Updating 9700 MIDI2CV8 circuit boards to change the IC13, pin 7 from a negative DC supply to ground (pin 8).

Solder side of 9700 MIDI2CV8 printed-circuit-board with a circle where the negative supply to pin 7 can be cut and an arc where pins 7 and 8 can be linked on IC13.

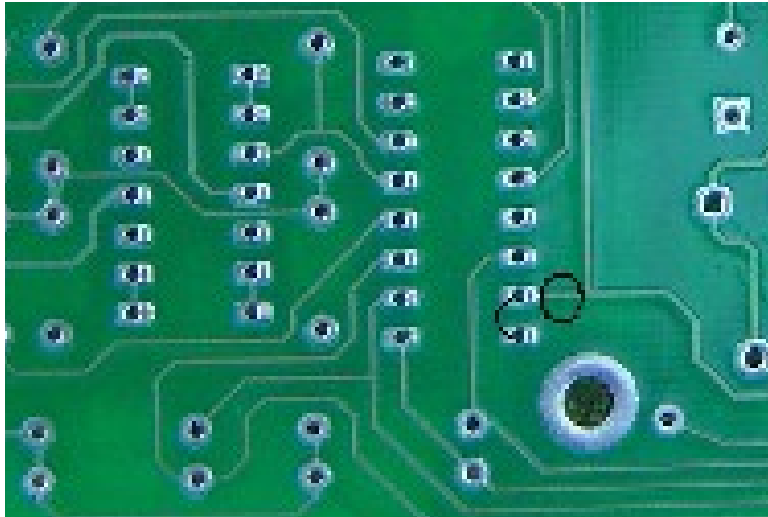
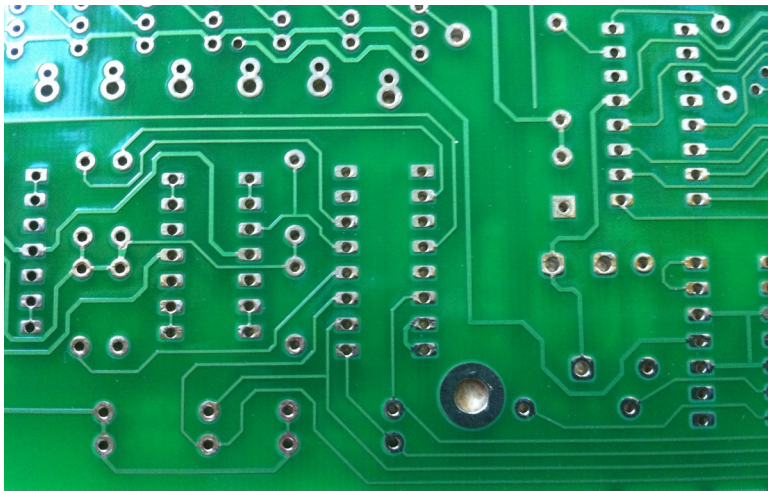
To ensure the voltages to the IC13 don't exceed the amount for normal operation, which could occur when the MIDI2CV8 is not a power supply for some other devices too (as with the P9700S) and in situations where it is powered from an external DC supply in a 15-18V range, pin 7 can be disconnected from the negative supply connection and connected with the 0V ground used by pin 8. If IC13 were passing negative voltages, pin 7 would have to have the negative supply, but working to provide positive V.C. only, it is acceptable to be at zero volts.

The "X" in the board image above is a cut to the trace connecting the negative DC supply to pin 7. Many boards were provided with the cut and a piece of 30ga. wire to link the pin 7 and 8 pads. If making the change on an older board, just lay a piece of tinned bare wire to span pins 7 and 8 and touch it with a hot iron tip to flow the solder on the pins and the wire link. Boards since April of 2011 are now made with this update in place.

MIDI2CV8 boards made after April 2011 have the IC13p7p8 update in place as shown above.
